ABERDEEN MIDDLE SCHOOL
HVAC SYSTEMIC RENOVATION

ADDENDUM NO. 4

DATE: March 27, 2024

PROJECT: Aberdeen Middle School
HVAC Systemic Renovation
111 Mt. Royal Avenue
Aberdeen, Maryland 21001
Gipe Project No. 23043

1 ENLARGED EQUIPMENT ROOM-NETWORK- LOWER ELEVATION
SCALE: 1/4" = 1'-0"

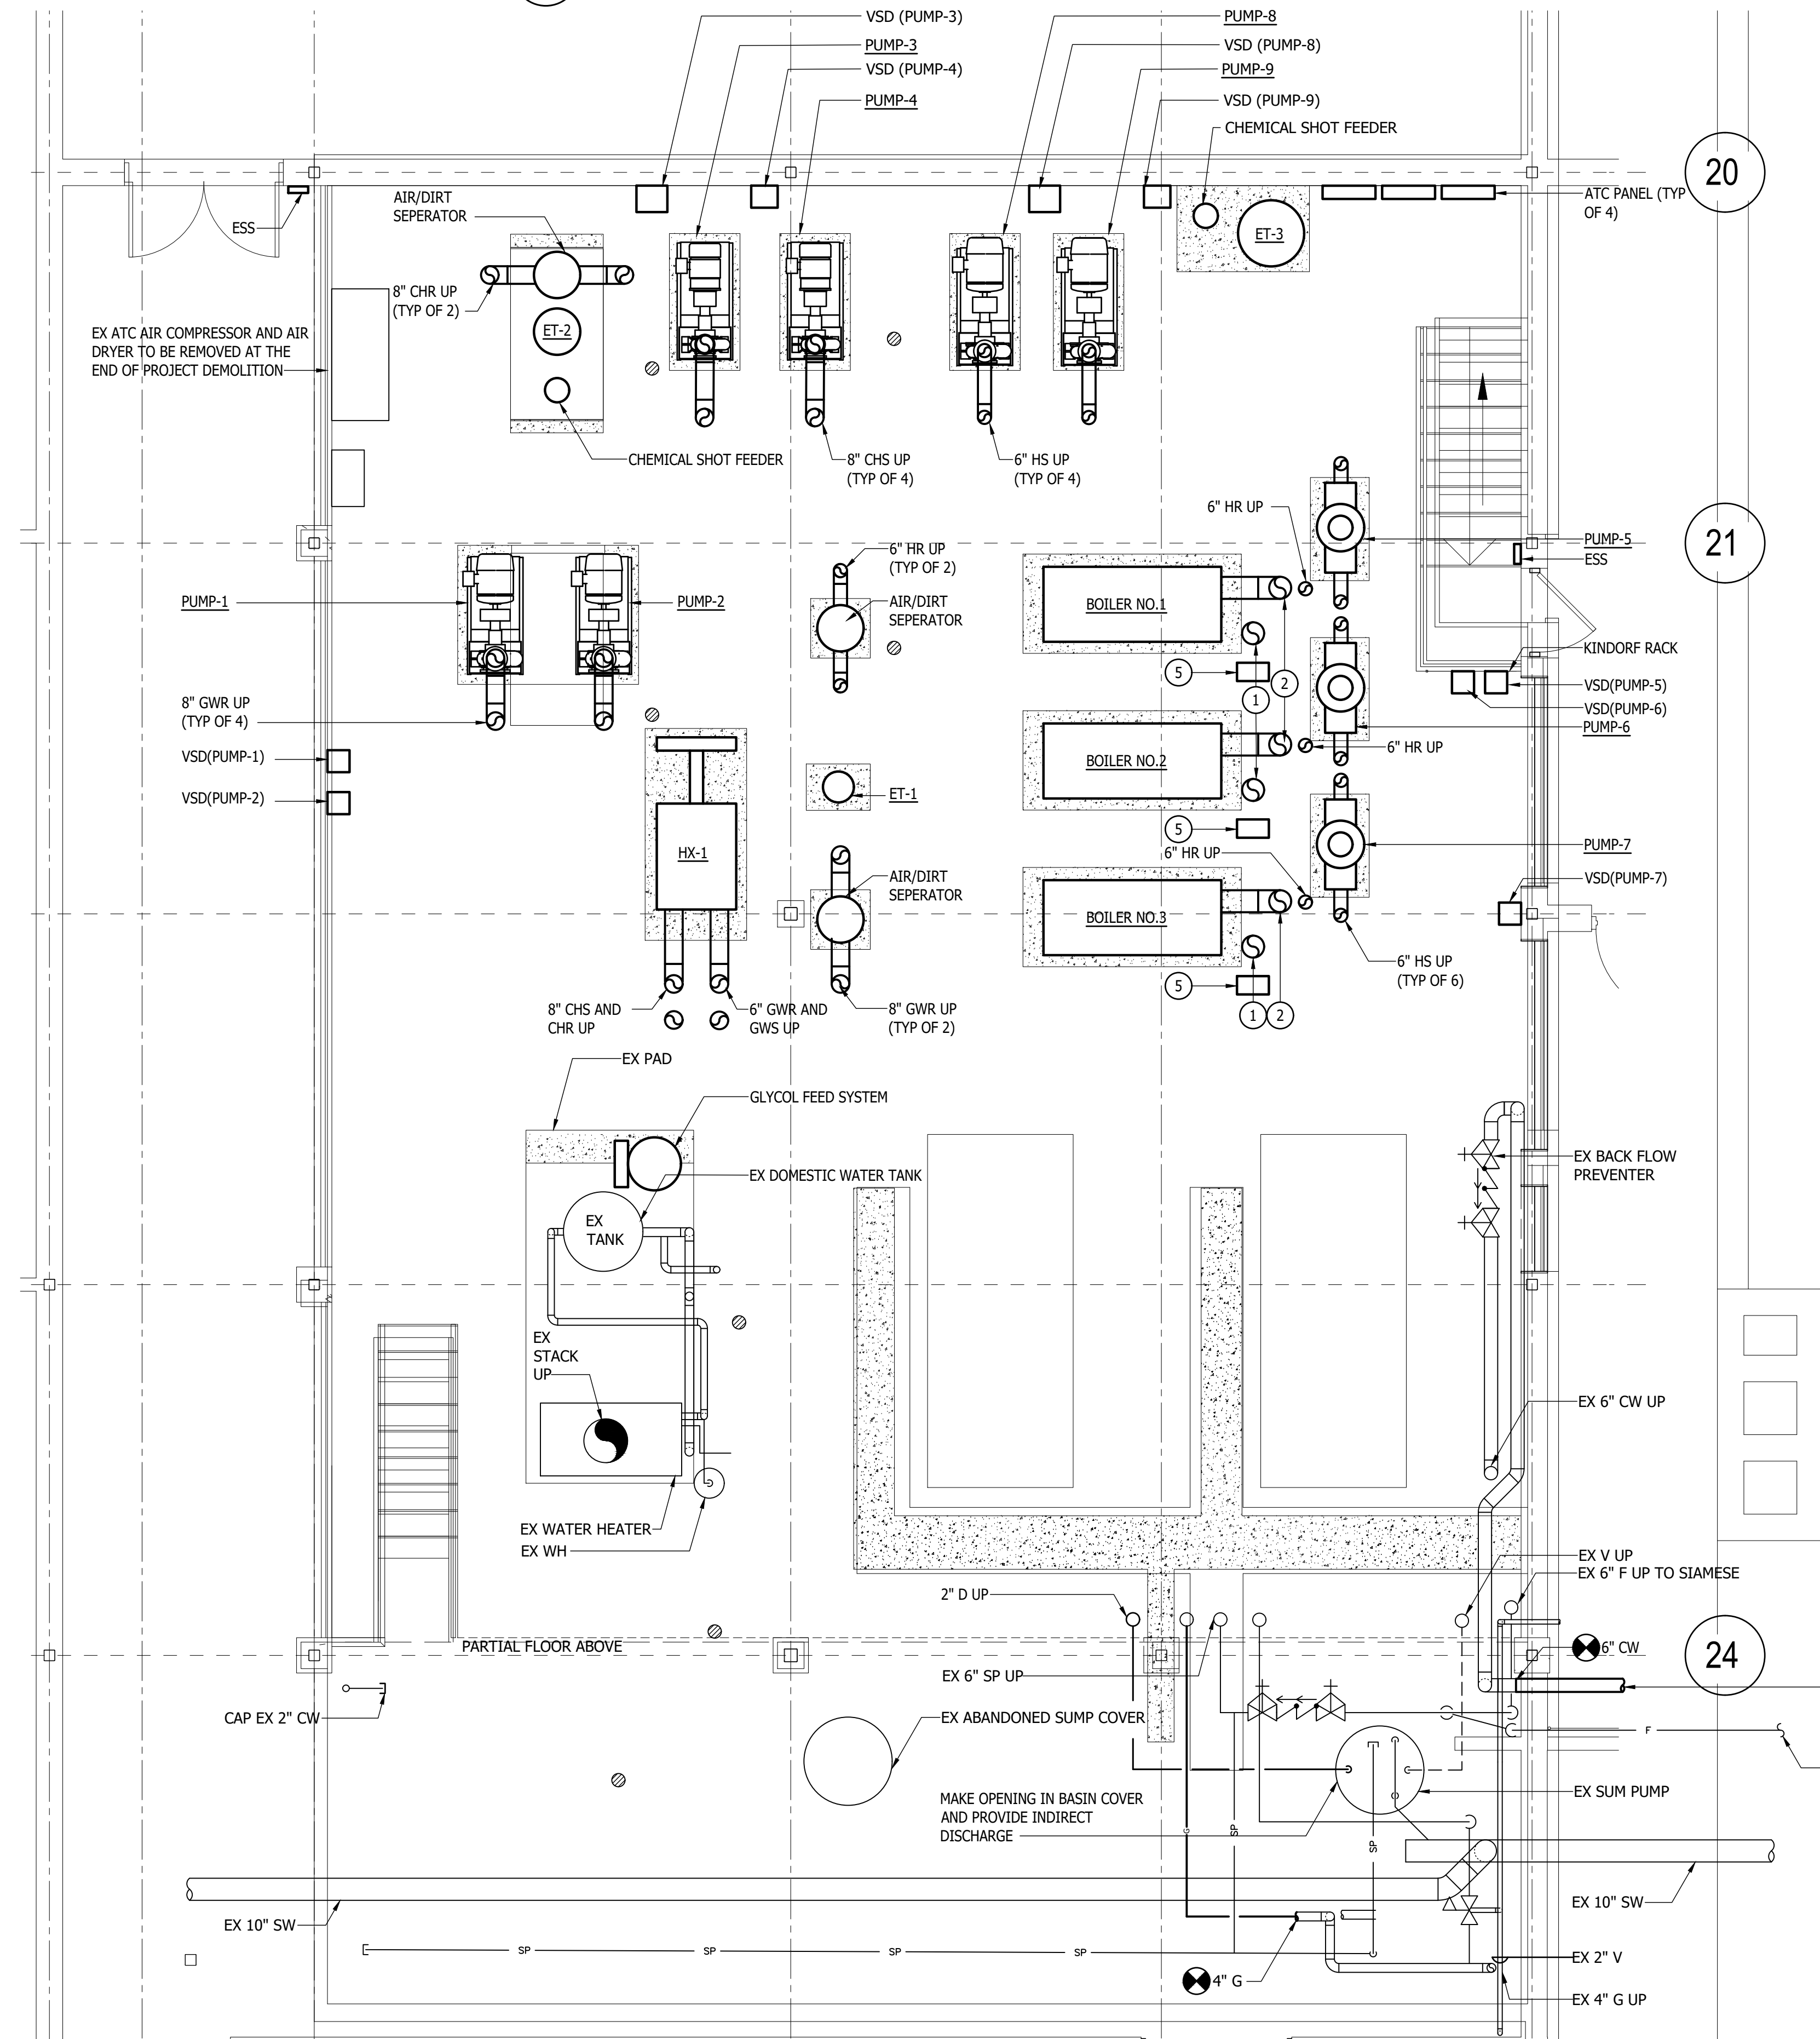
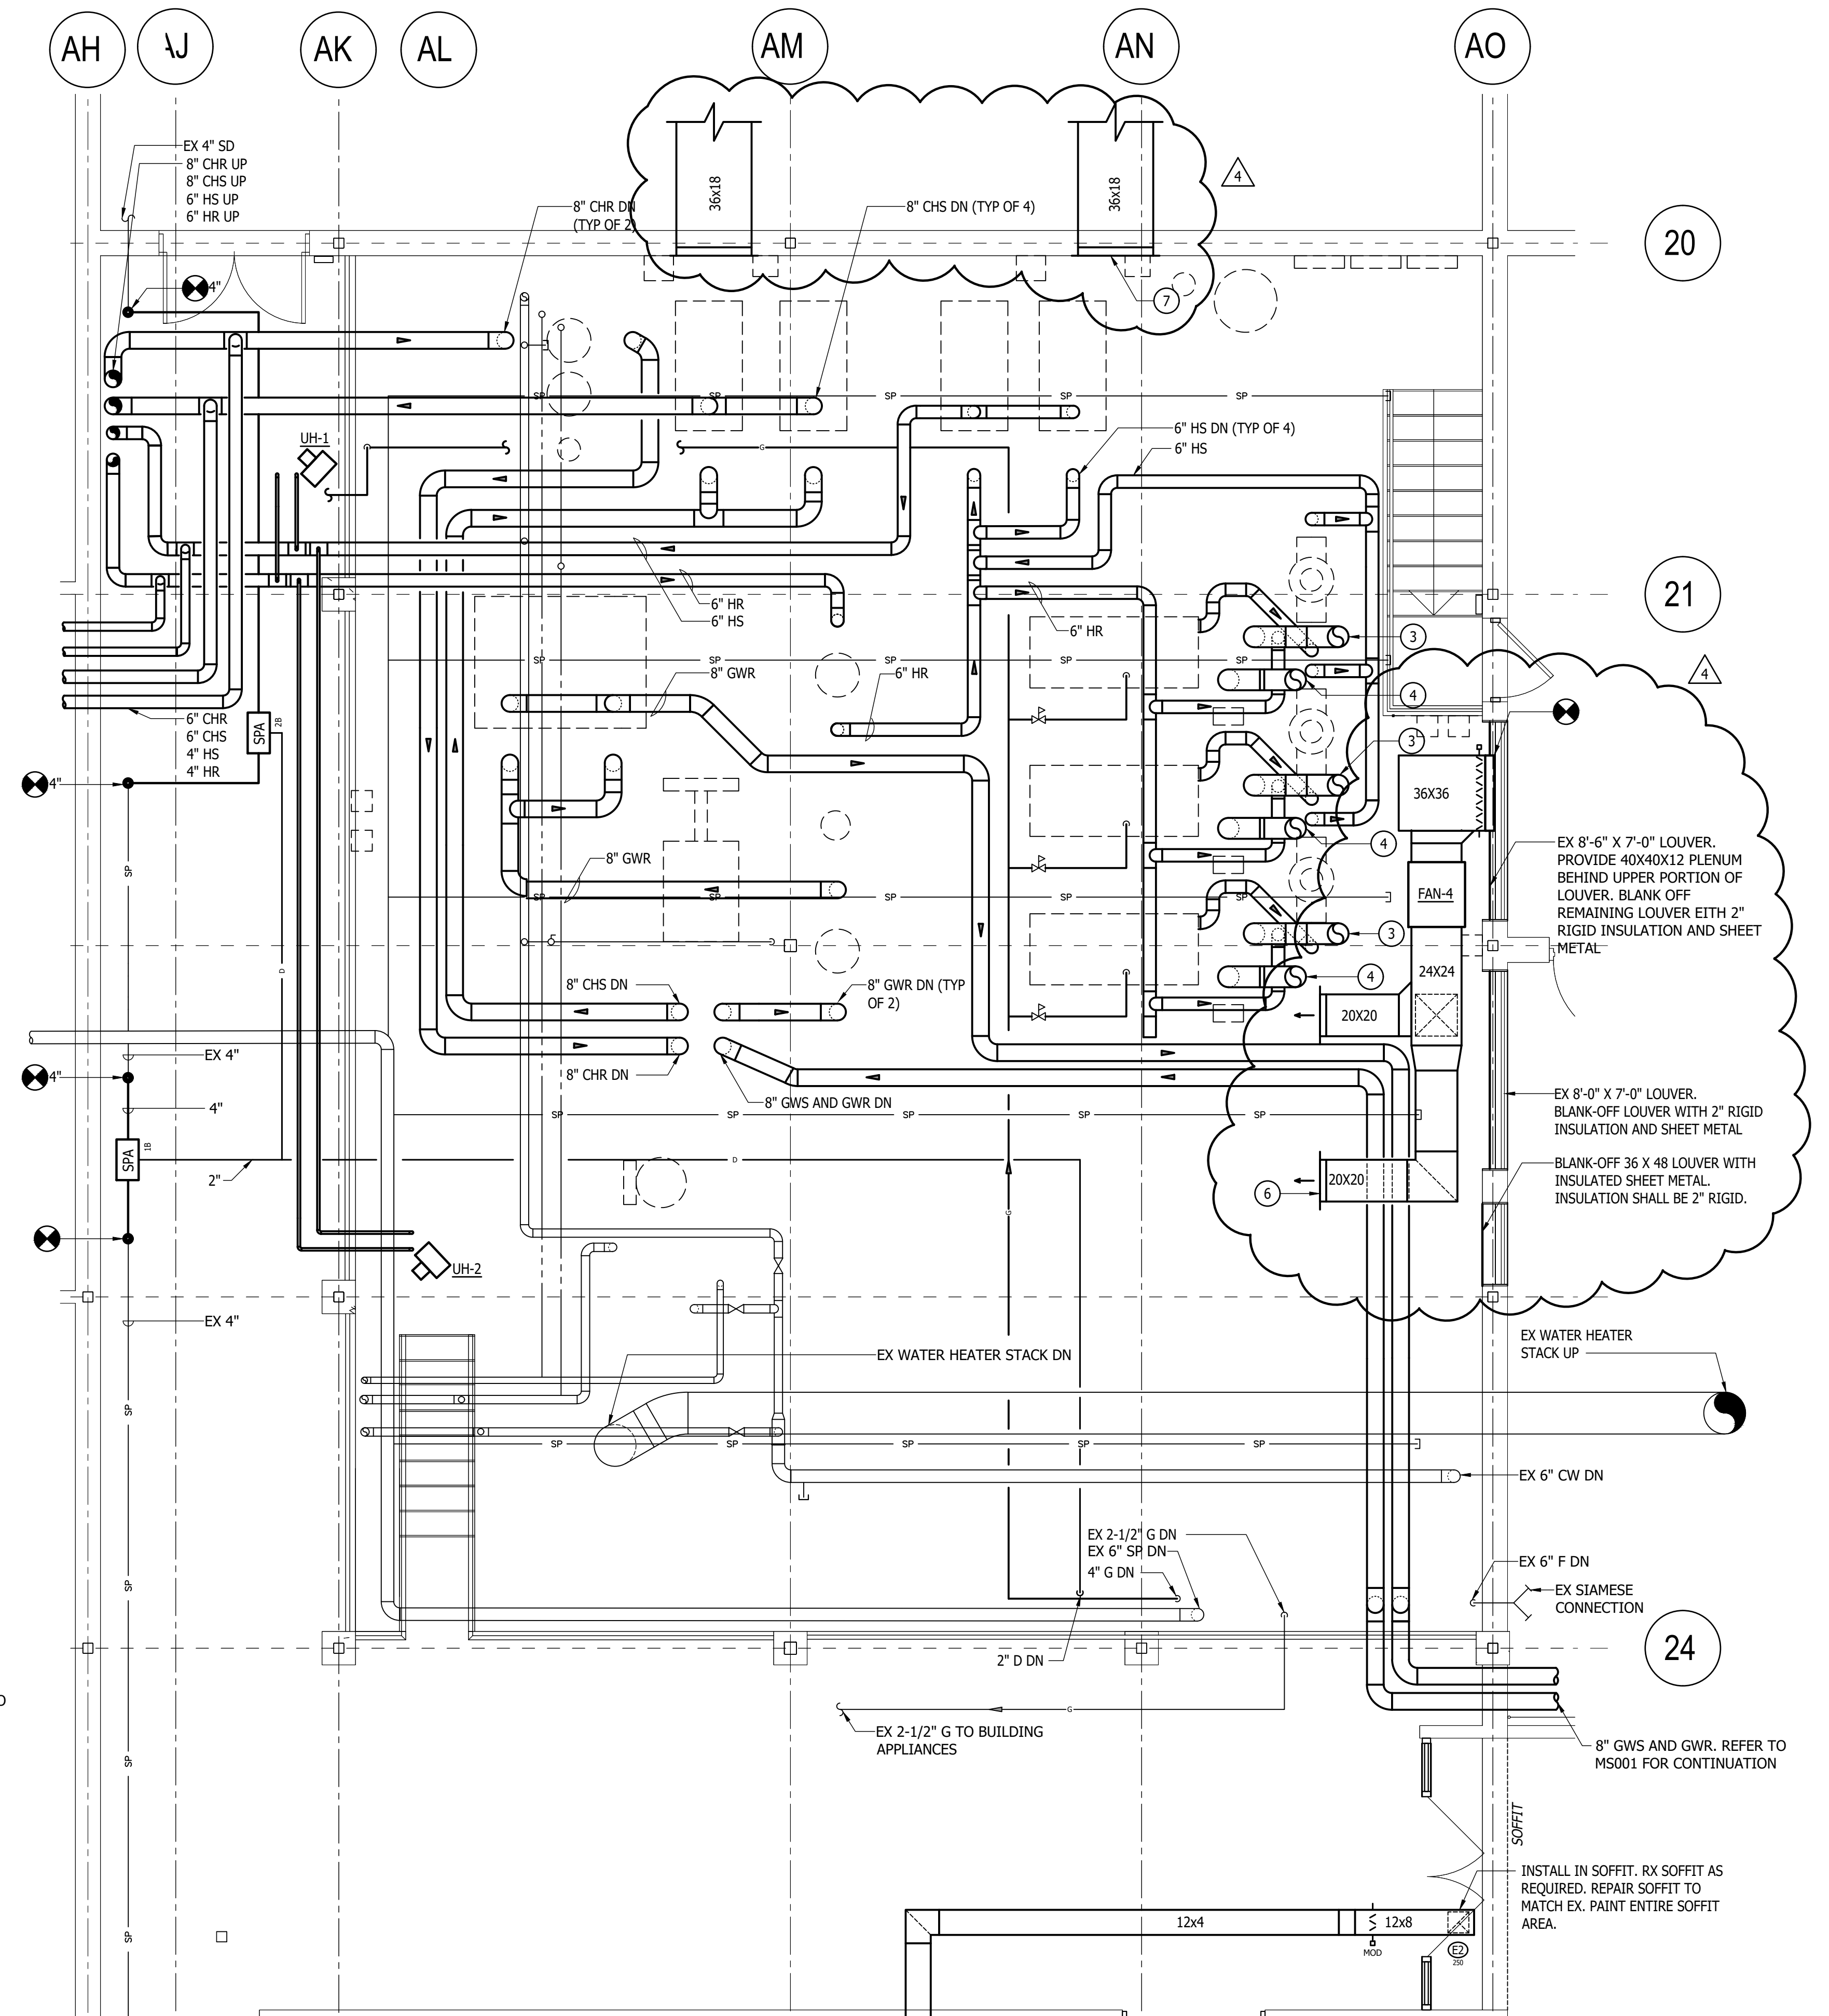
1. All Civil Drawings.
Remove the words “NOT FOR CONSTRUCTION”.
2. **M203 – LOWER LEVEL AREA E – NEW WORK**
See attached revised drawing.
3. **M303 – ENLARGED EQUIPMENT ROOM NEW WORK**
See attached revised drawing.
4. **M705 – DETAILS**
See attached revised drawing.
5. **ES001 – ELECTRICAL SITE PLAN**
